15M PERFORATOR REQUIREMENTS, PROCEDURES, AND LUBRICATION

1.001 This addendum supplements Section P36.640, Issue 1, which contains the apparatus requirements, adjusting procedures, and lubrication instructions for the maintenance of the 15M perforator.

1.002 This addendum is issued to bring up to date the tension requirements for the antichatter lever spring.

Fig. 13

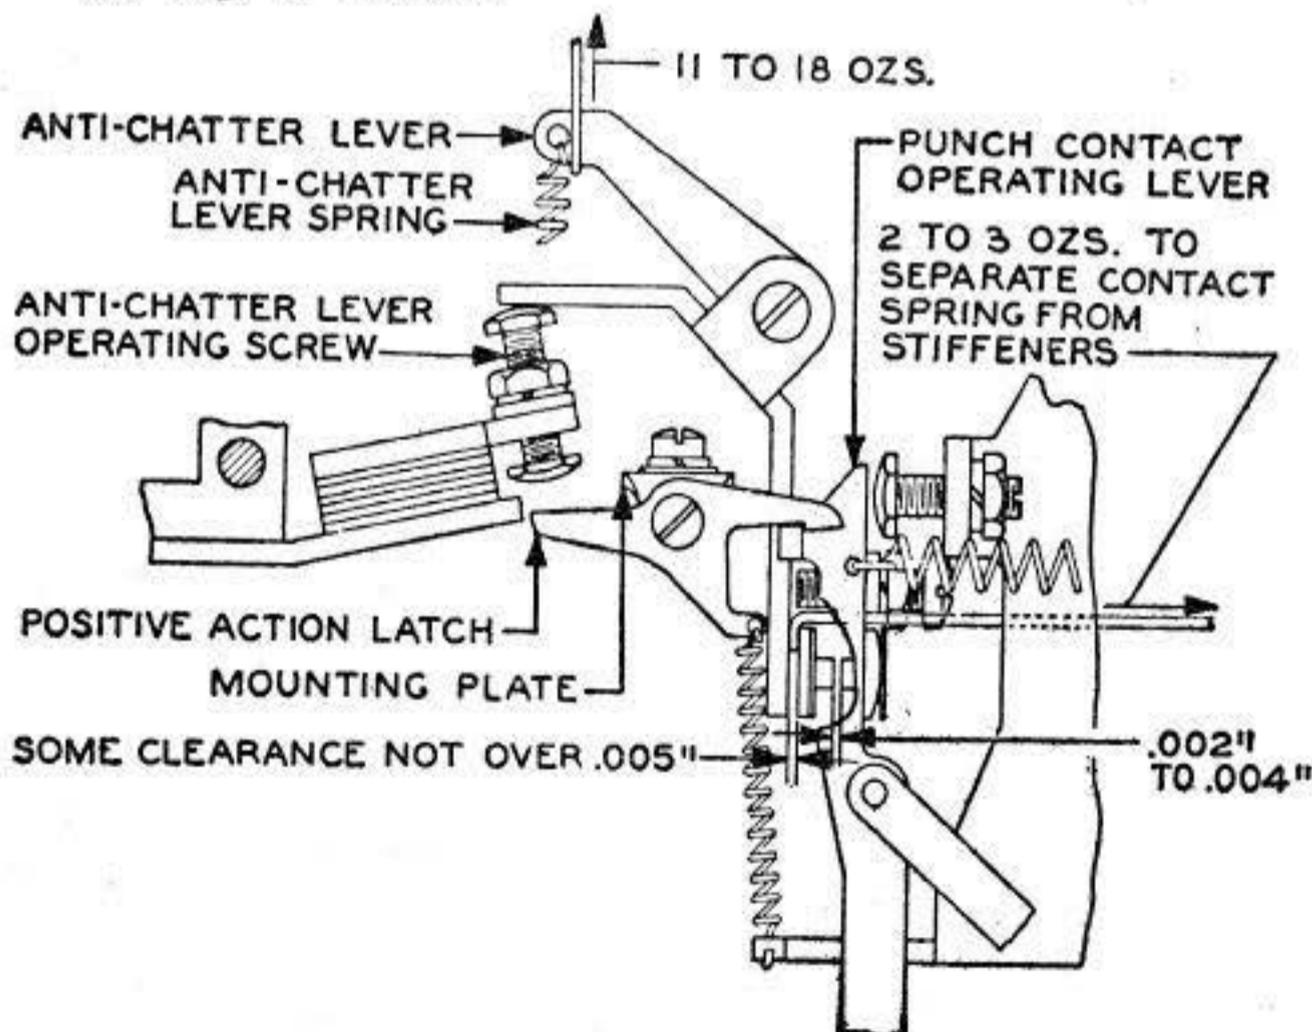
(a) Fig. 13—revised
